Minutes of the Regular Meeting of the Albany County Airport Authority

February 9, 2026

11.1 Authorization of Change Order 18 for Construction Contract 21-1082-GC for the Terminal Expansion (Site Work) to MLB Construction Services, LLC.

11.2 Authorization of Change Order 10 for Construction Contract 21-1082-INT STR for the Terminal Expansion (structural & Interior) to MLB Construction Services, LLC.

ENLARGED
 CONSTRUCTION FINISH &
 ELEVATION PLANS -
 KIDS' ZONE -
 LEVEL 1

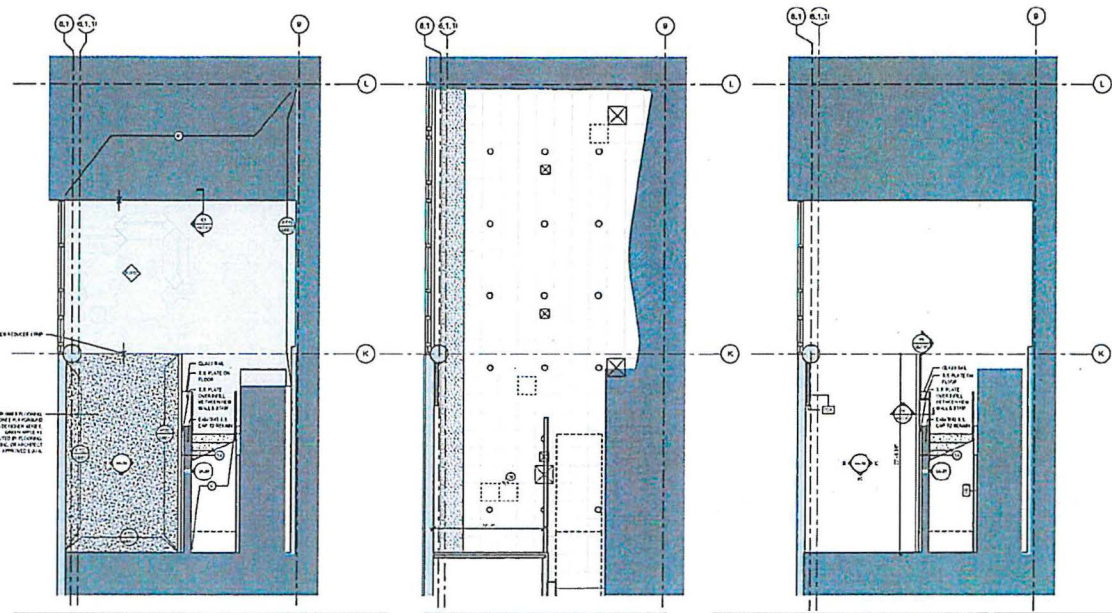
2. *Modifications to the finished design of the Children's Play Area. These modifications address owner requested change from an aquatic theme, reflected in the finishes of the original design, to a woodland theme reflected in the revised design. It does not include responses to contractor RFIs with respect to the construction of this area. (\$5,545)*

Sheet No.  
**E-102**

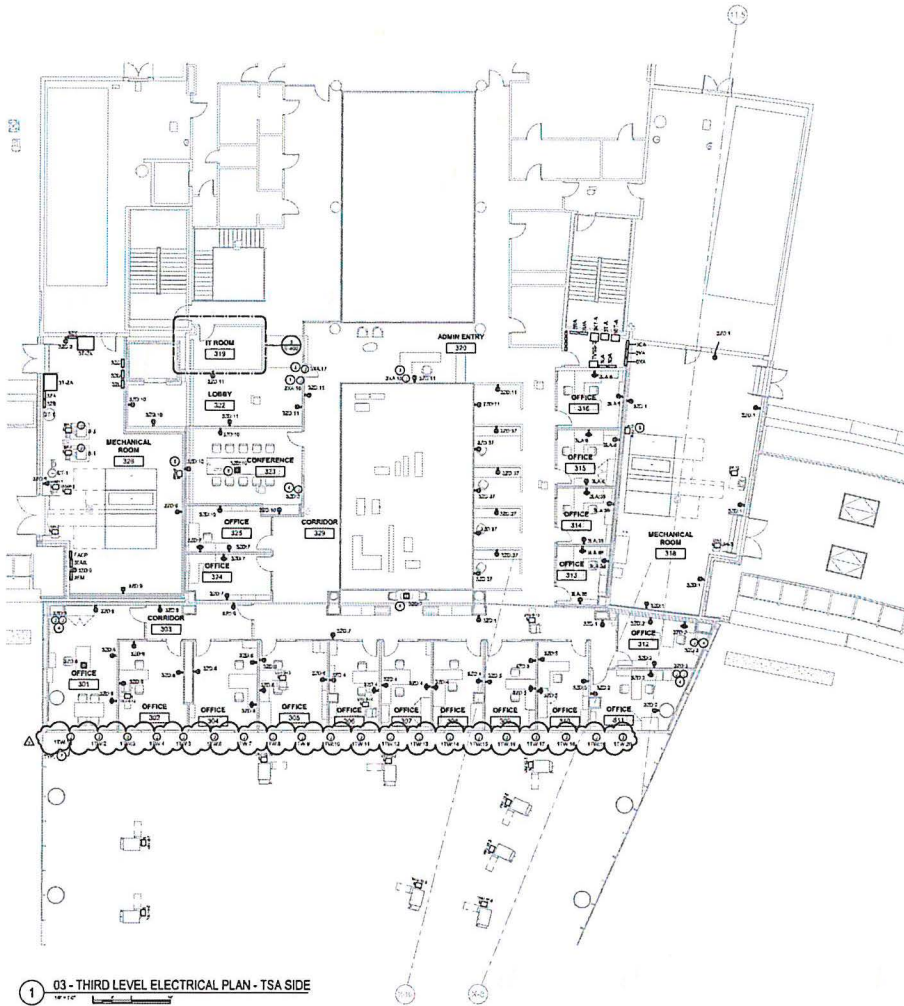
| Item # | Qty      | U/M | Q/M | Size              | Description                                                                                          | Material Unit | Material Result | Labor Unit | Labor Result |
|--------|----------|-----|-----|-------------------|------------------------------------------------------------------------------------------------------|---------------|-----------------|------------|--------------|
|        | 0.00     |     |     |                   | DWG E-102 ADDED 1-HEAT TRACE POWER CIRCUIT FROM PNL 32B (EXCLUDES FURNISH AND/OR HEAT TRACE INSTALL) |               |                 |            |              |

E-105

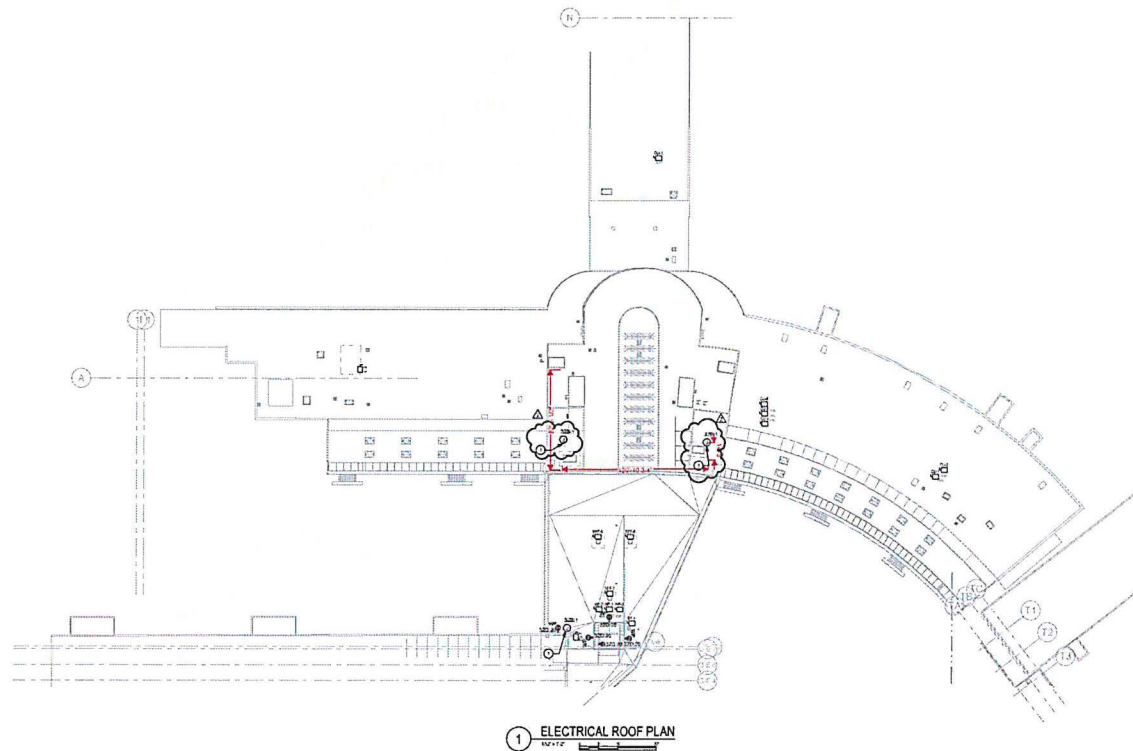
| Item # | Qty      | U/M | Q/M | Size              | Description                                                                                                       | Material Unit | Material Result | Labor Unit | Labor Result |
|--------|----------|-----|-----|-------------------|-------------------------------------------------------------------------------------------------------------------|---------------|-----------------|------------|--------------|
|        | 0.00     |     |     |                   | <b>DWG E-105 ADDED JUNCTION BOXES &amp; BREAKER LOCKS &amp; WIRE DEAD_END PORTS</b>                               |               |                 |            |              |

Drawn By  
**E-107**

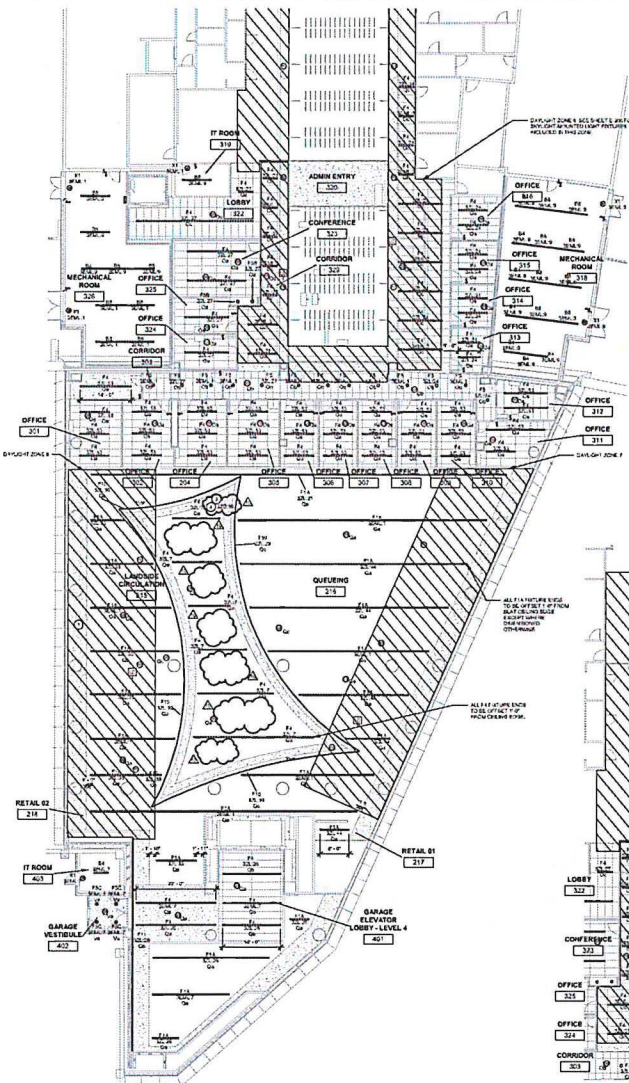
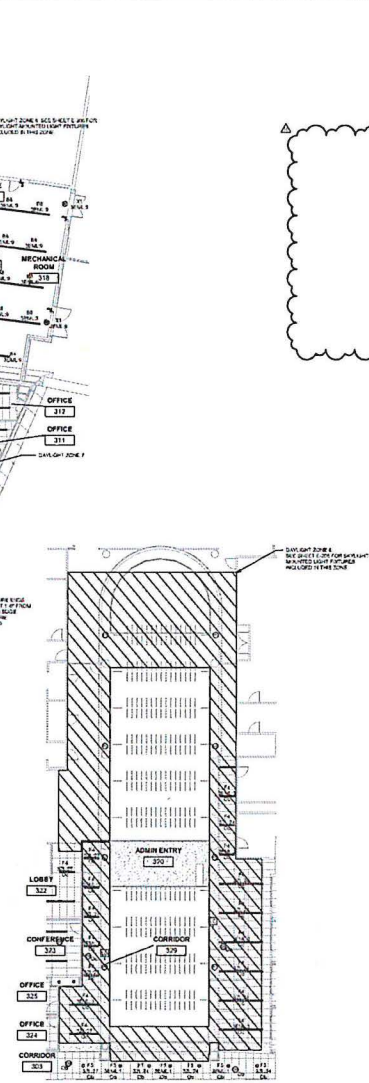
| Item # | Qty      | U/M | Q/M | Size              | Description                                                                                                       | Material Unit | Material Result | Labor Unit | Labor Result |
|--------|----------|-----|-----|-------------------|-------------------------------------------------------------------------------------------------------------------|---------------|-----------------|------------|--------------|
|        | 0.00     |     |     |                   | <b>DWG E-107 ADDED 2-HEAT TRACE POWER CIRCUIT CONNS FROM PNL 3ZB (EXCLUDES FURNISH AND/OR HEAT TRACE INSTALL)</b> |               |                 |            |              |

E-400

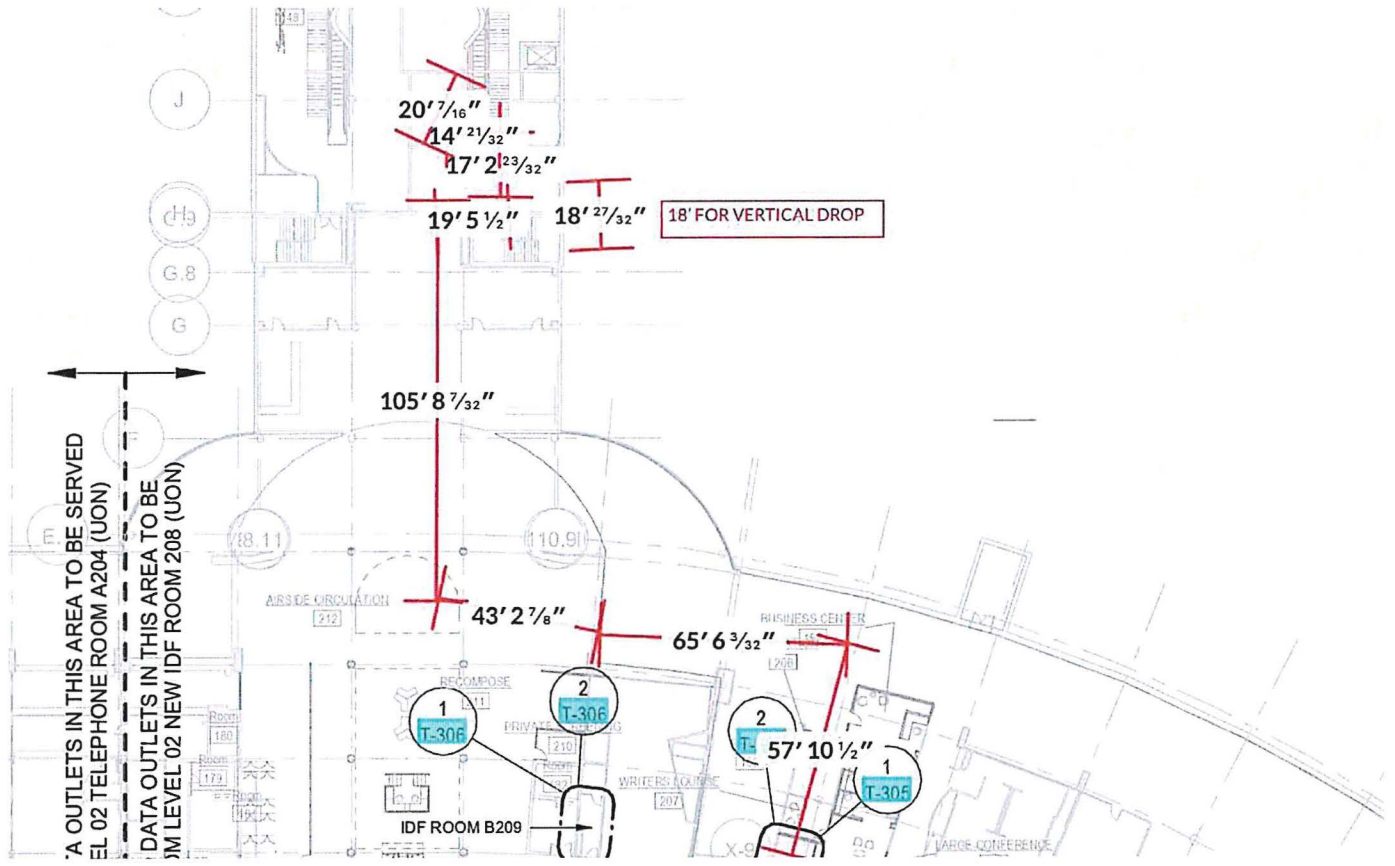
- Remove 250 - Type D1A and 100 - Type D1B Bocci Pendant Lights. 1-power circuit to remain to a junction box for future use.
- Dwg E-400; Furnish and install IT Room 208 circuits from existing Panel 1LS vs. Panel 3ZD. There are 8 circuits (24-conductors) to be contained in 2-conduits. Panel 1LS will require the addition of 200' per conduit. The route above Concourse B ceiling has been included herewith.

13 COLUMN COVER W/ ROLLING GATE JAMB BELOW 6'

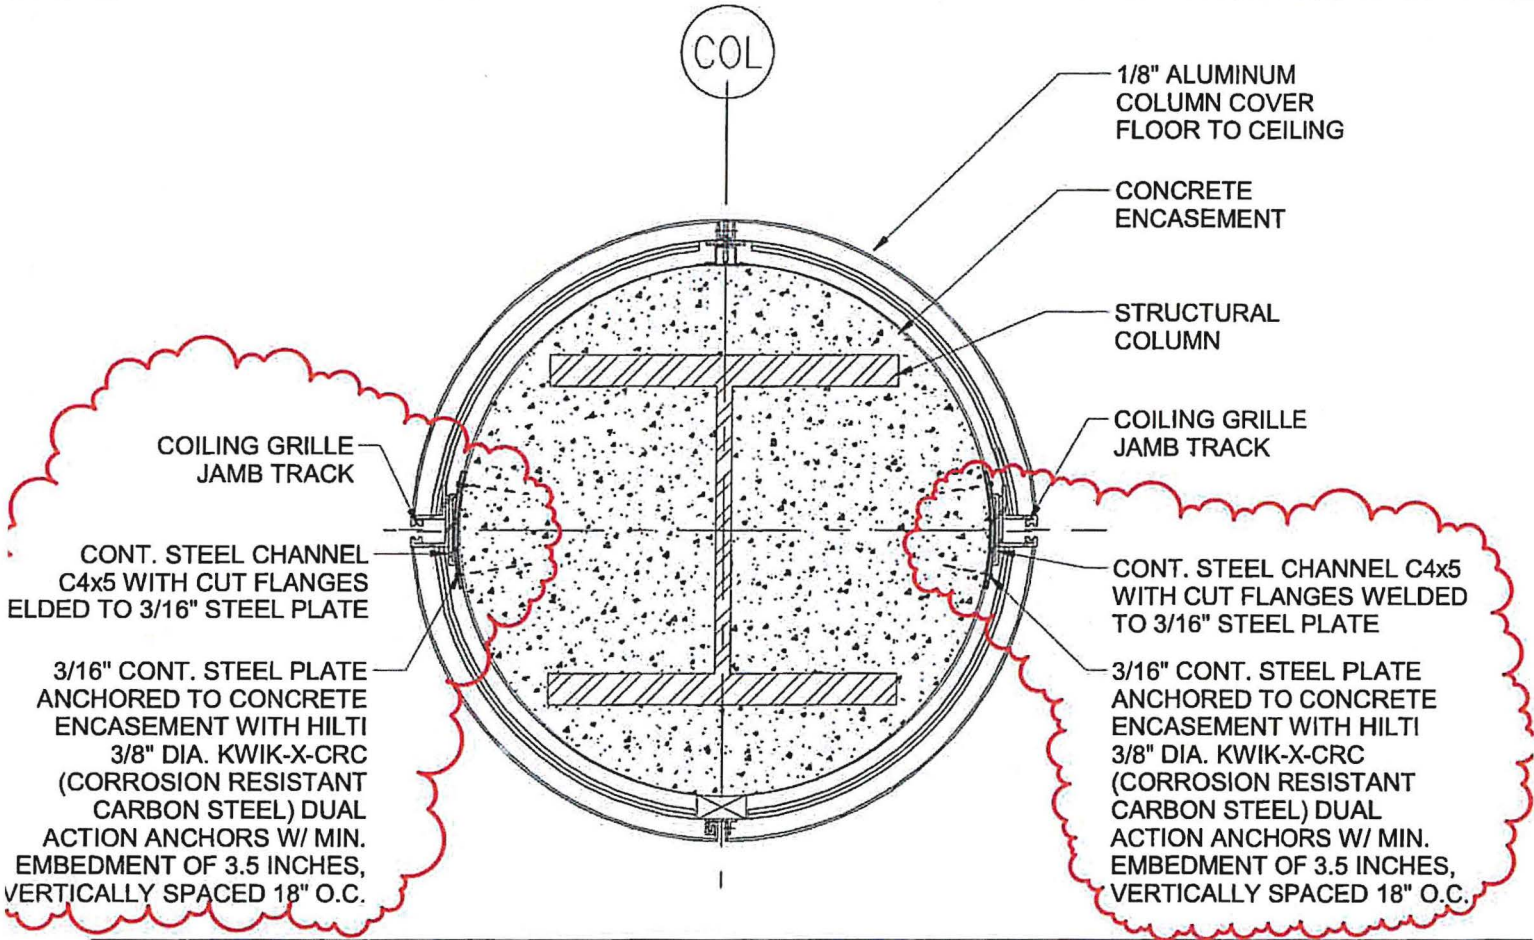
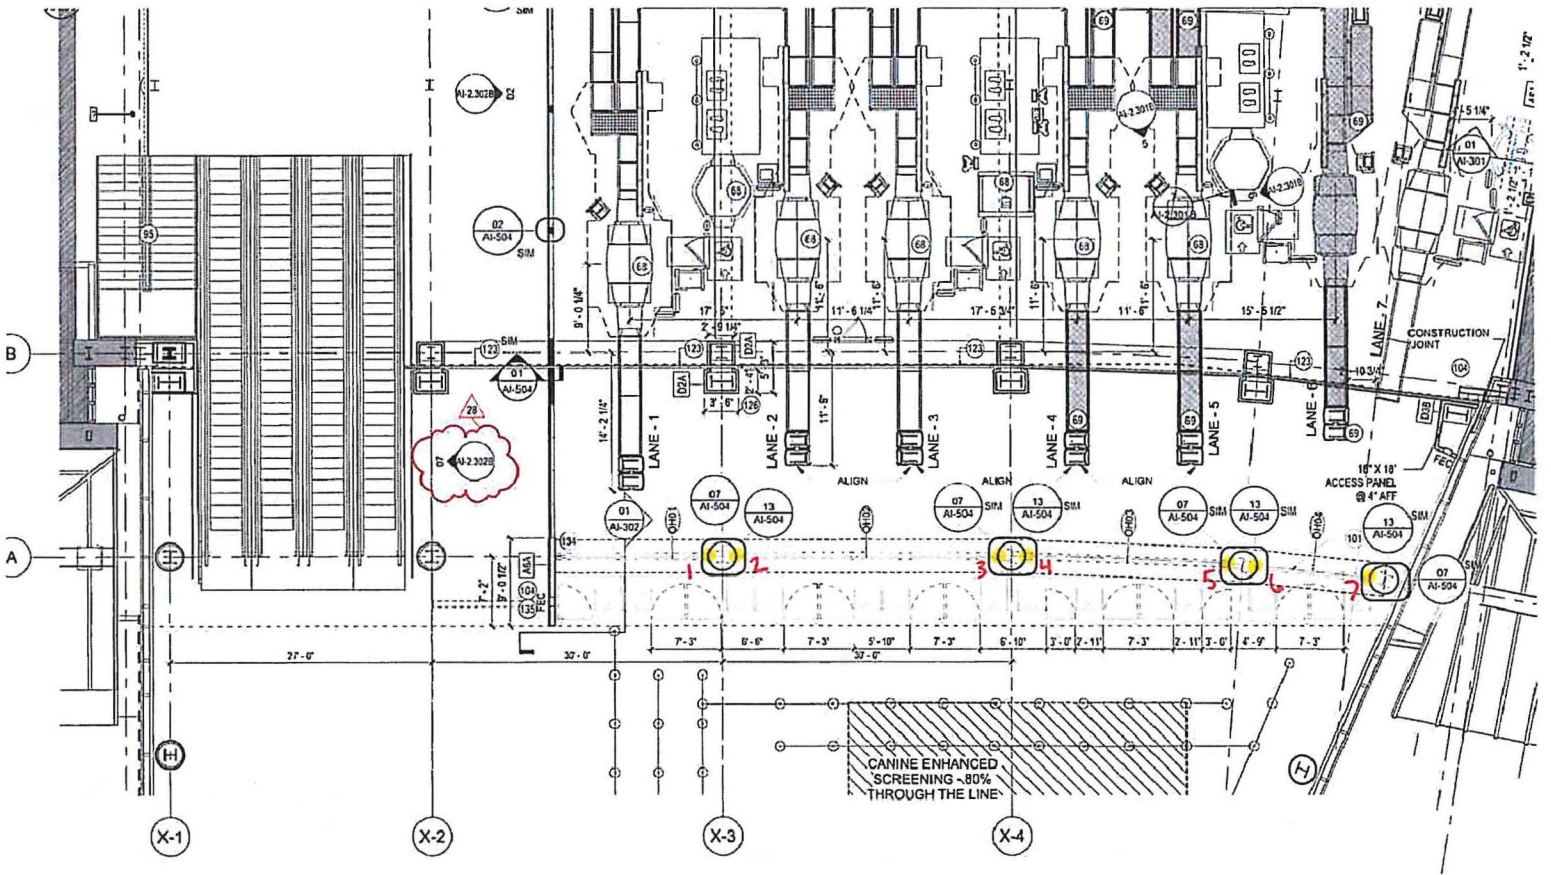
A.) See attached concept sketch for the grille track attachment to the concrete encasement. Details 7 and 13 on AI-504 were produced in ASI-114. Particularly detail 13, Overhead Door Co has stated they cannot accommodate. Overhead Door is the basis-of-design. The concept sketch attached was discussed in the field with all involved. MLB needs the size of the channel specified, the size/spacing of the fasteners specified, and direction on if the channels are in fact to be filled with grout as discussed. If so, provide specifications on grout to be used.

* CHANNEL & TRACK MAY NEED TO SHIFT NORTH/SOUTH IF GRILLE NEEDS TO BE CENTERED ON COLUMN. CHA TO ADVISE AND/OR REVISE OVER DETAIL.

- A. Refer to attached revised detail 13/AI-504 for jamb track at concrete encased column.
- B. Refer to attached Rolling Gate Jamb detail at TSA wall.

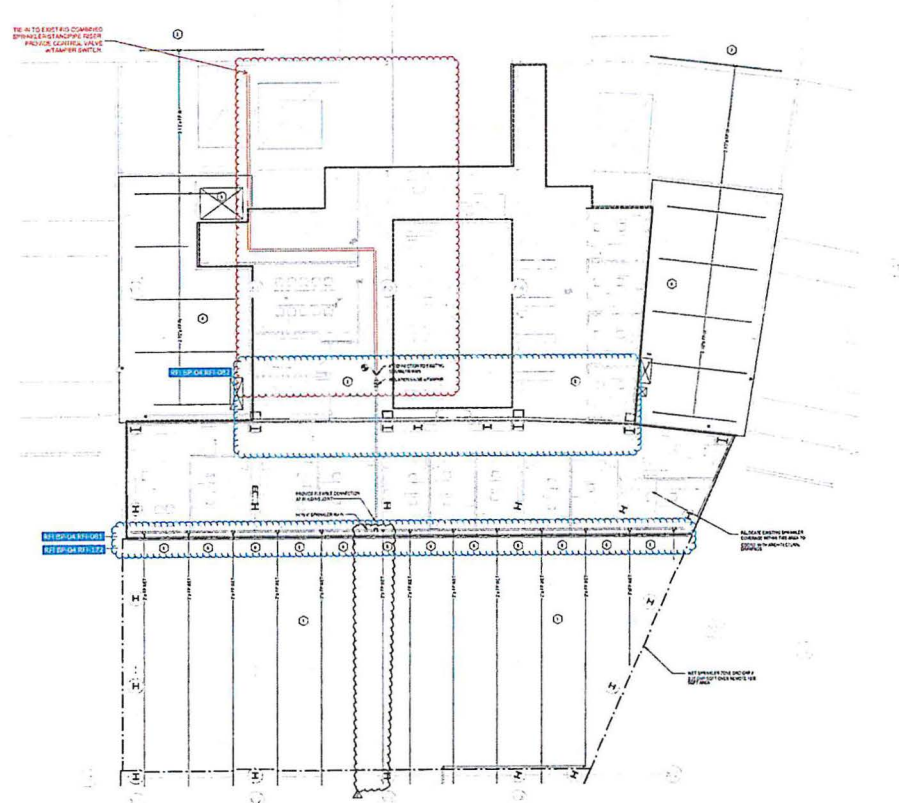
Contract drawing FP-105 calls out connecting to an existing 4" main in the office area to feed the 3rd floor bridge sprinkler system. After an above ceiling review it was found that there are no 4" mains present in this area. It is a 3" that reduces to 2-1/2". A 4" main is needed for the bridge sprinkler system to work hydraulically.

Per the response to RFI-351, drawing FP-105 indicates a proposed extension of the pipe routing in order to connect to the existing sprinkler main for the 3rd floor.
